# THE VILLAS AT CLAREMONT RANCH

### STREET IMPROVEMENTS PLANS

SF-22-028

## STORM SEWER PLANS

THE VILLAS AT  
CLAREMONT RANCH  
CONSTRUCTION DRAWINGS  
STREET IMPROVEMENT PLANS

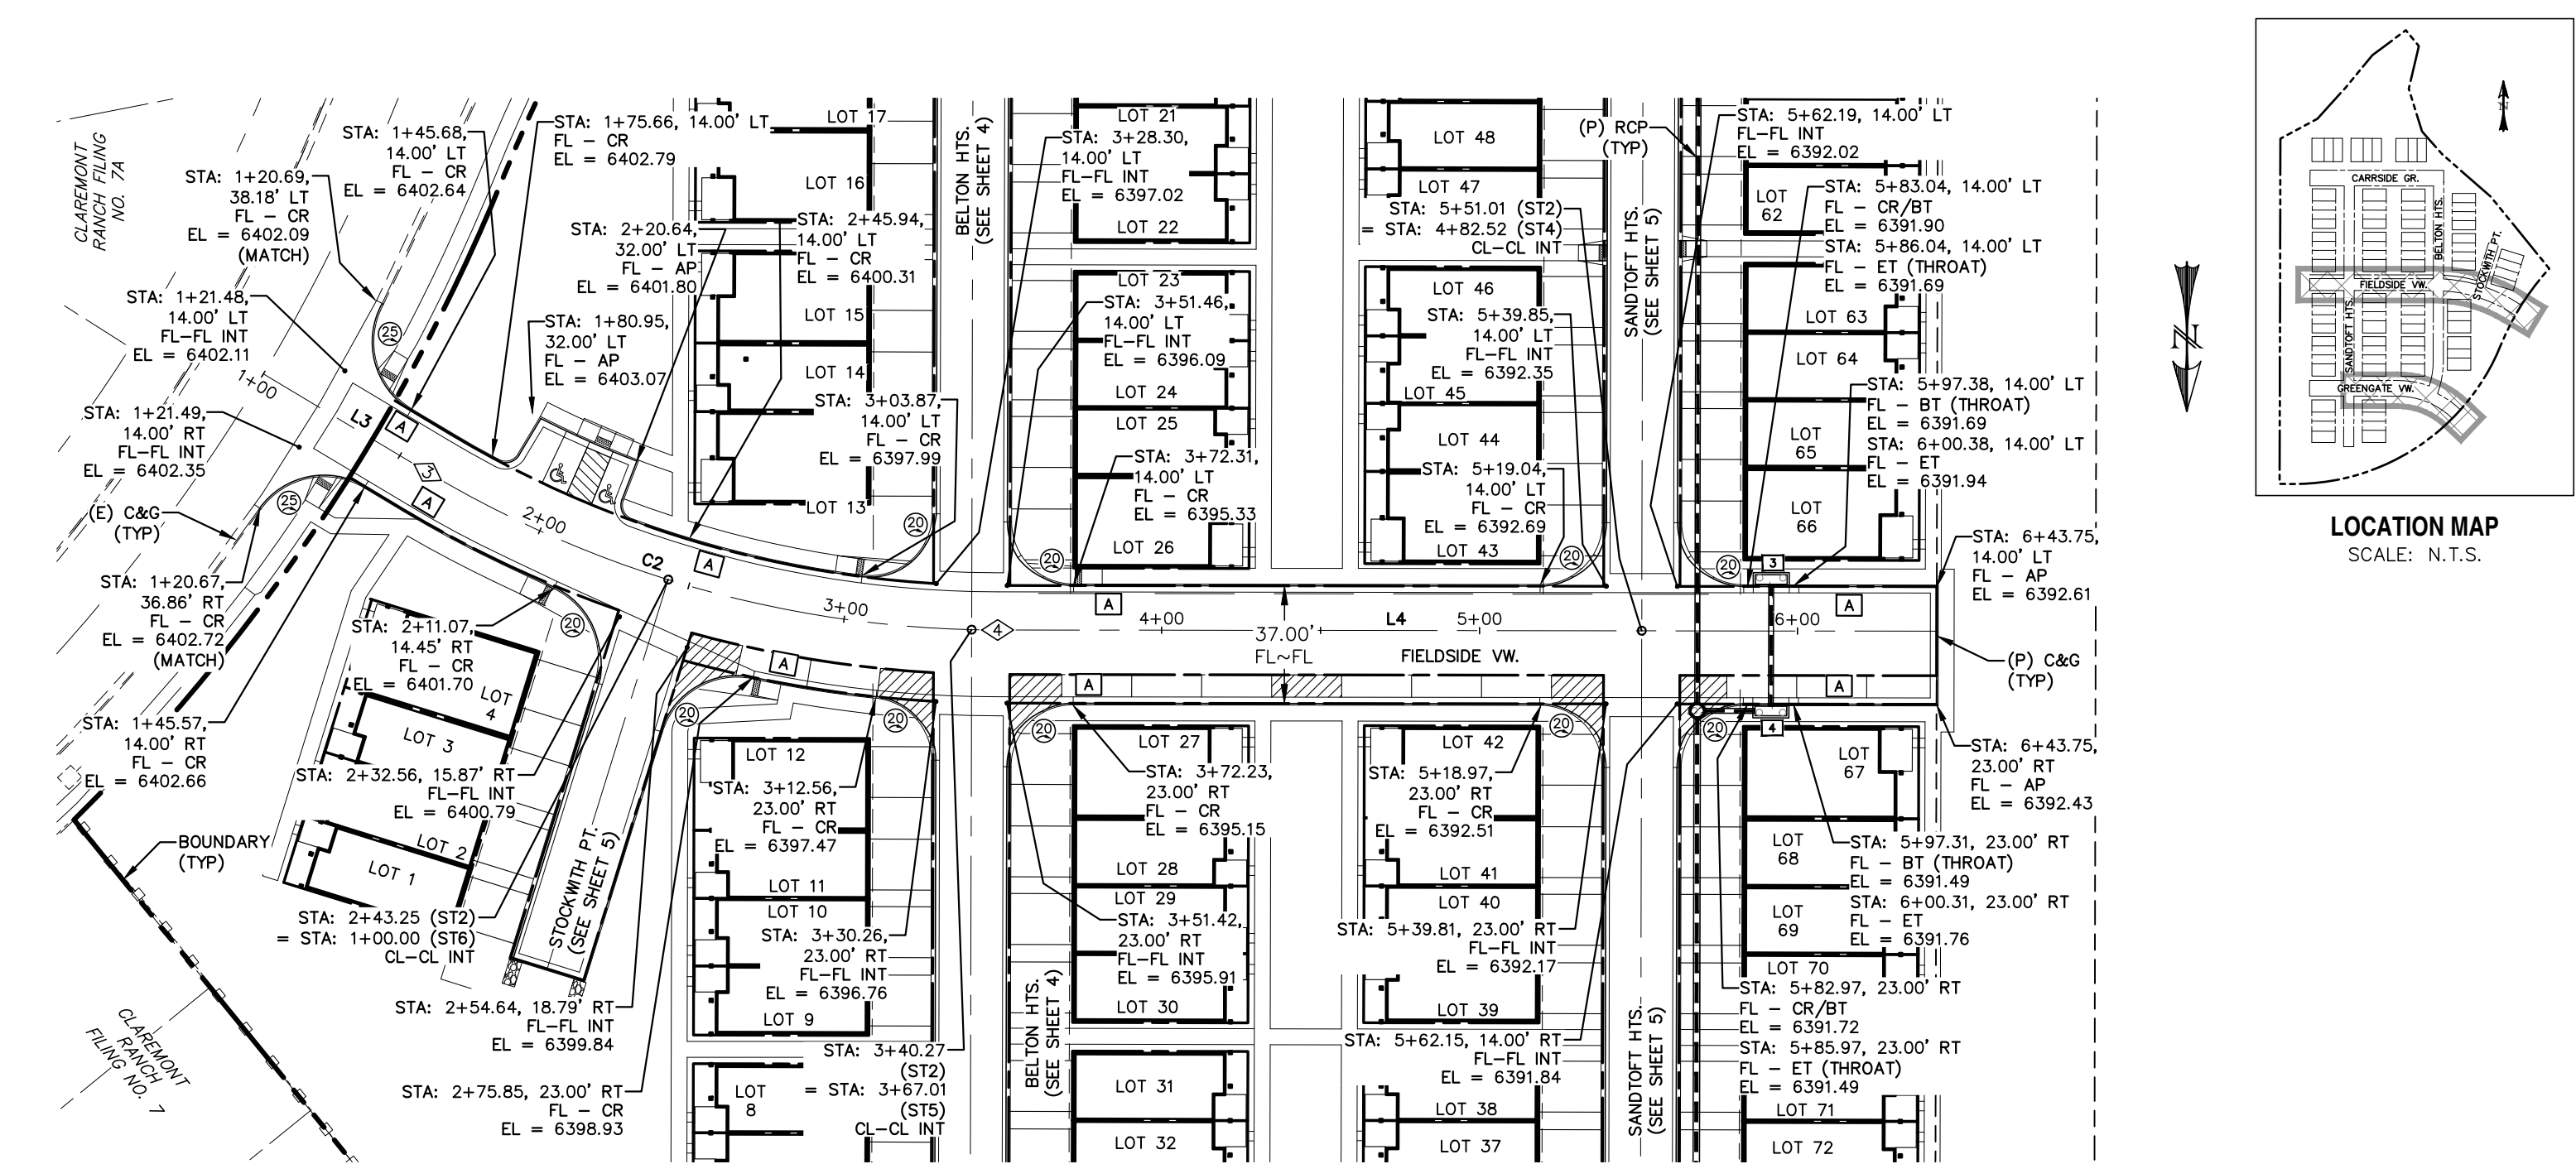
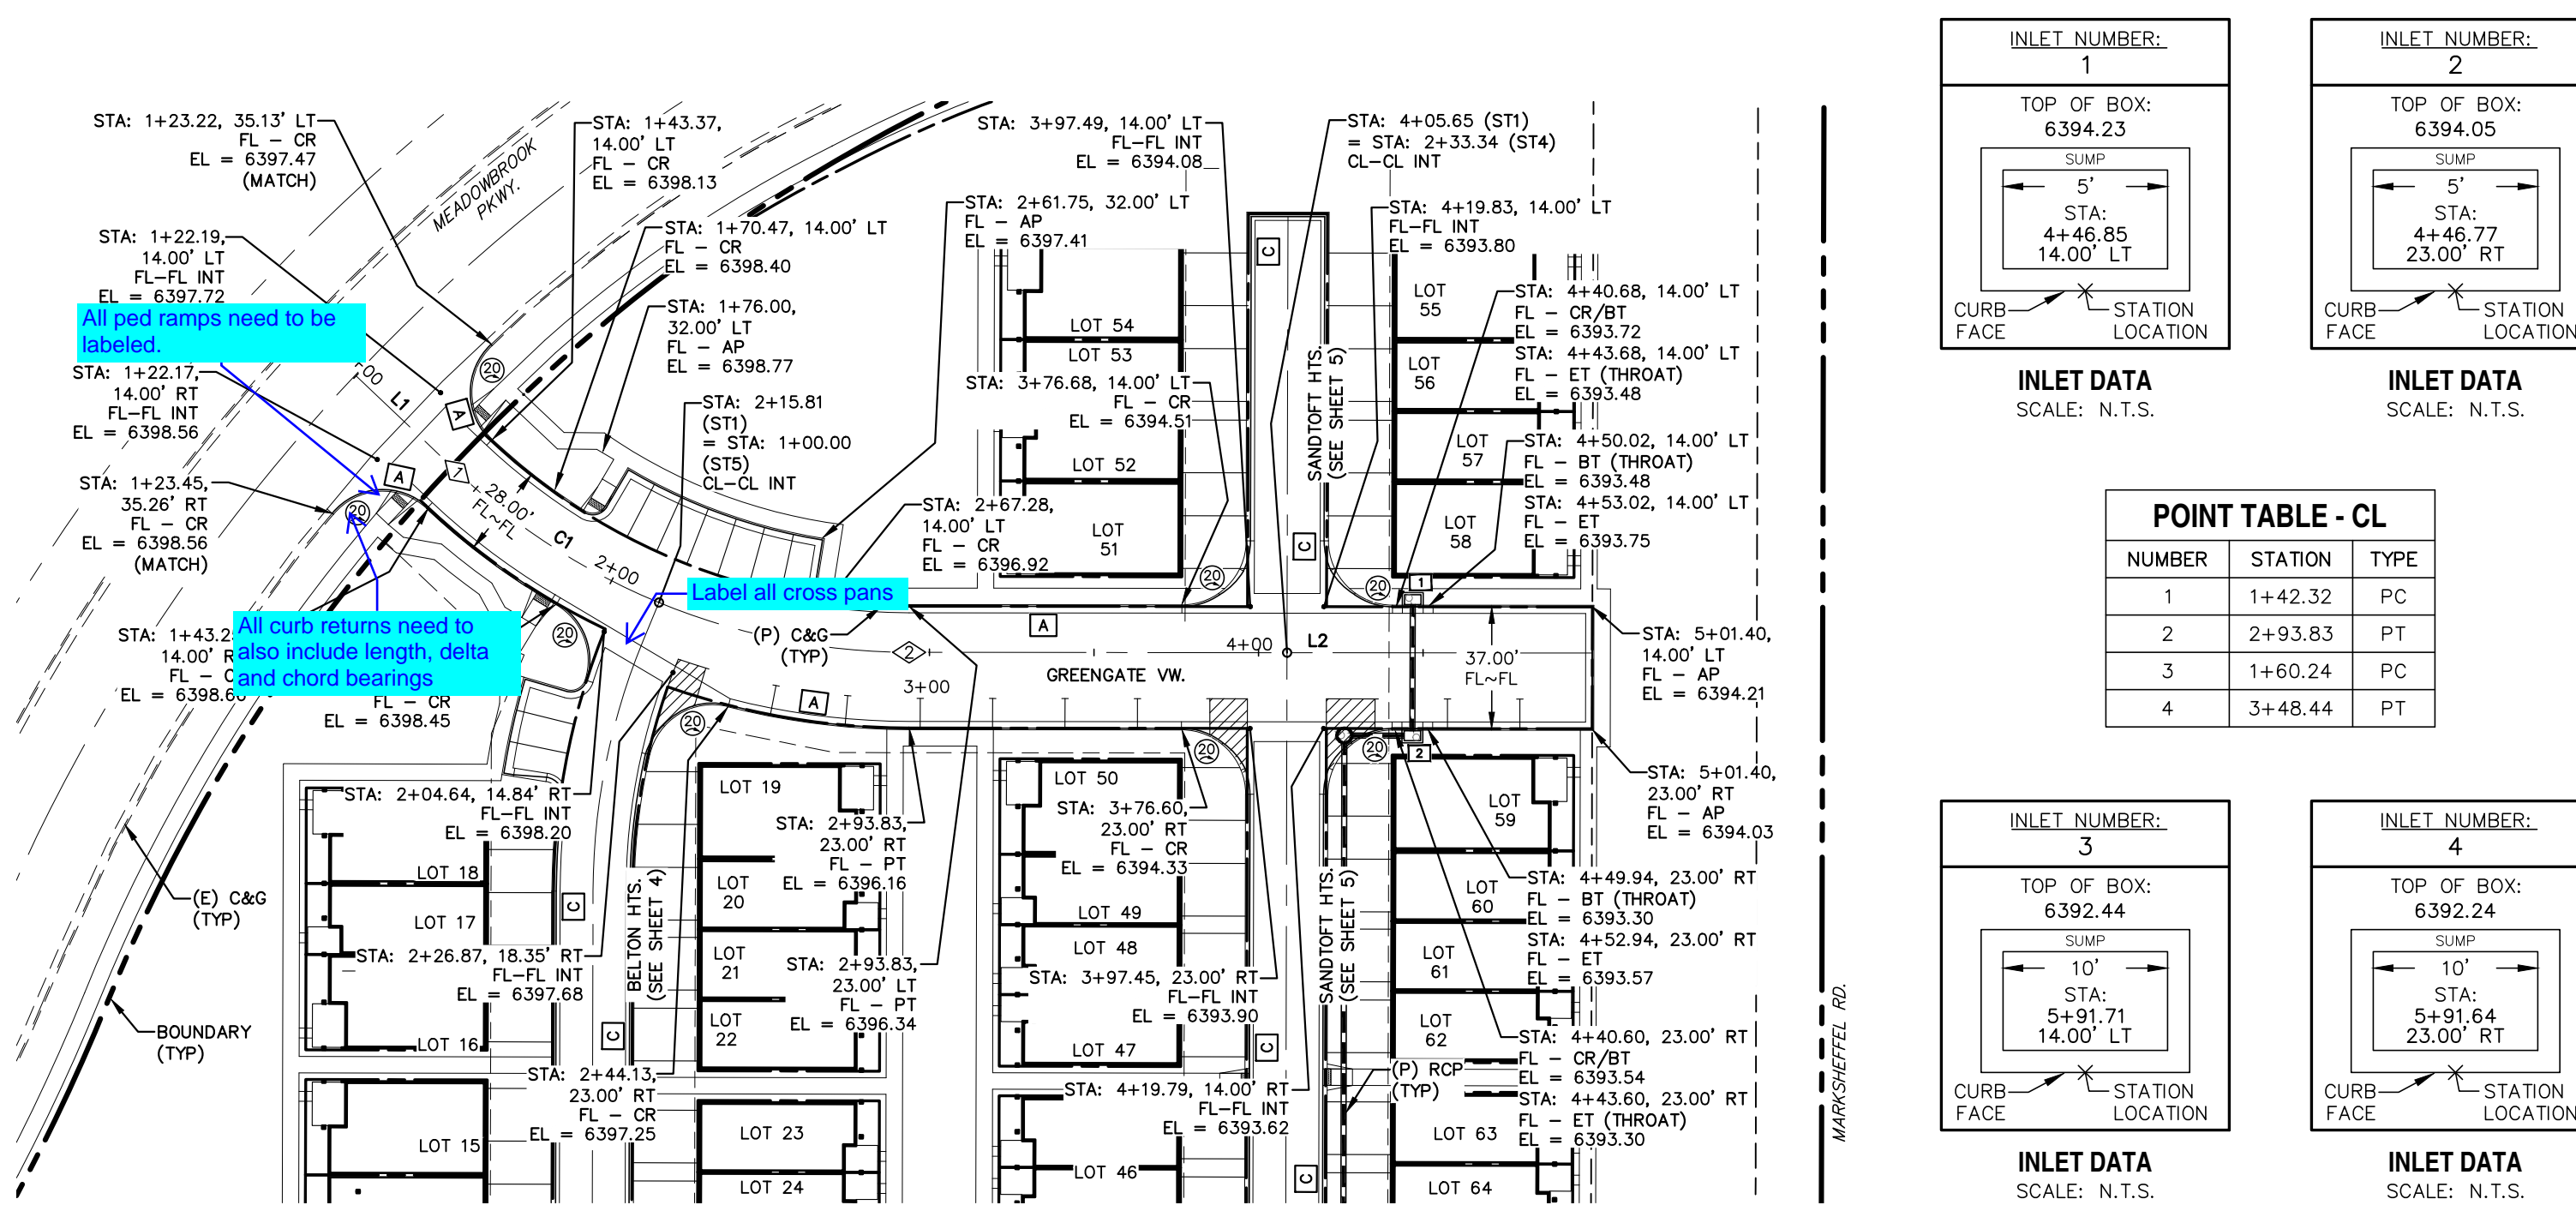
Need typical cross section of streets, including road classification & design/posted speeds.

Need details for: Curb & gutter, Curb transition, Pedestrian ramps, Cross pans
